6-November-2020

RE: Response to Technical Evaluation Comments and Information Request
#3 for Underground Injection Control (UIC) Permit Application Class VI
Pre-Construction Permit Application No. R9UIC-CA6-FY20-1

Evaluation of the AoR Delineation Modeling Approach for CES-Mendota Class VI Permit Application

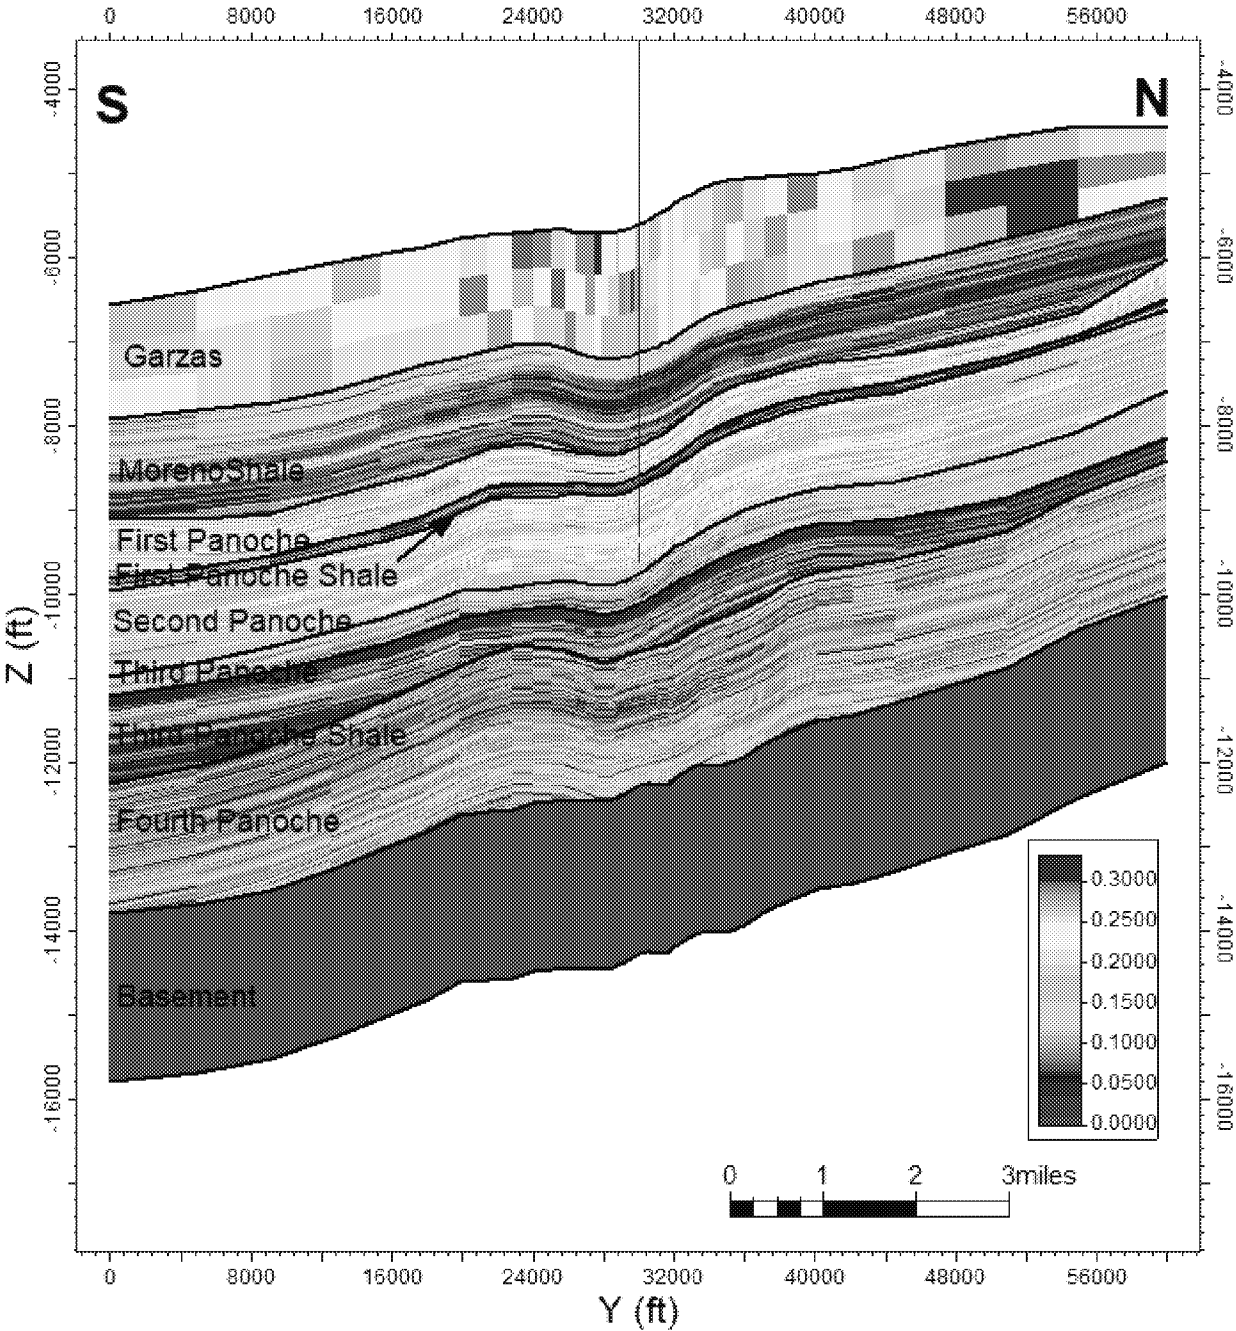
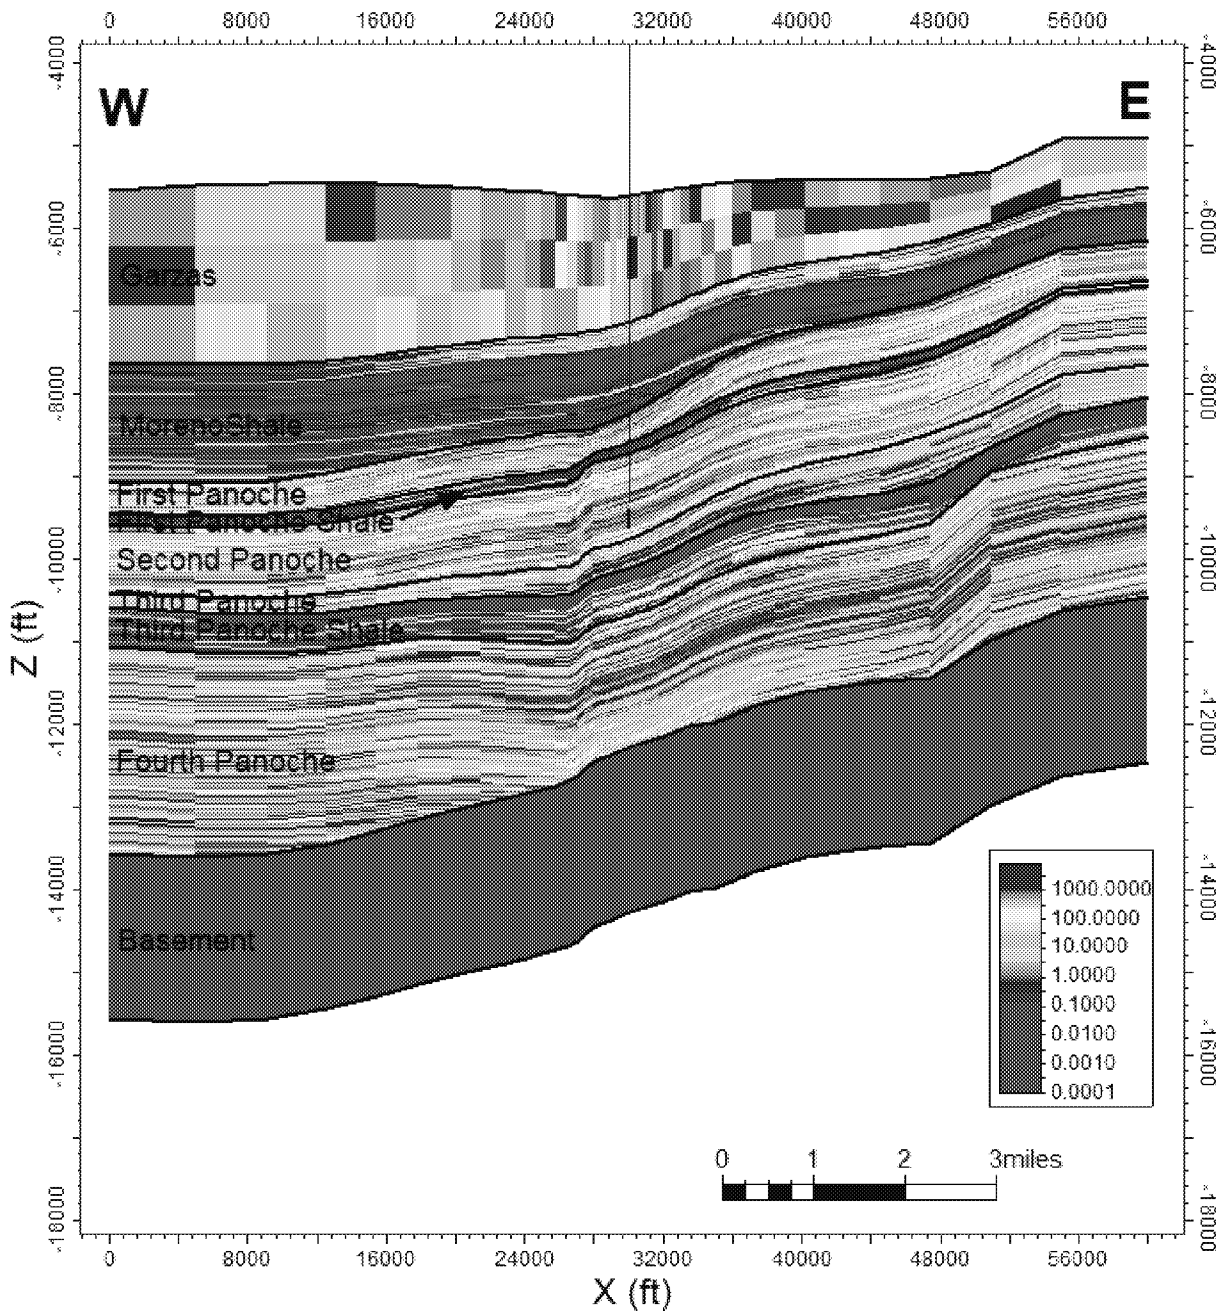
2.3.1	"The upscaled porosity and permeability graphics in Attachment B (Figures 3 and 4) would benefit from labeling for formation tops."	<i>The figures were updated with formation tops in Figure 7 and Figure 8 (refer to Appendix A).</i>
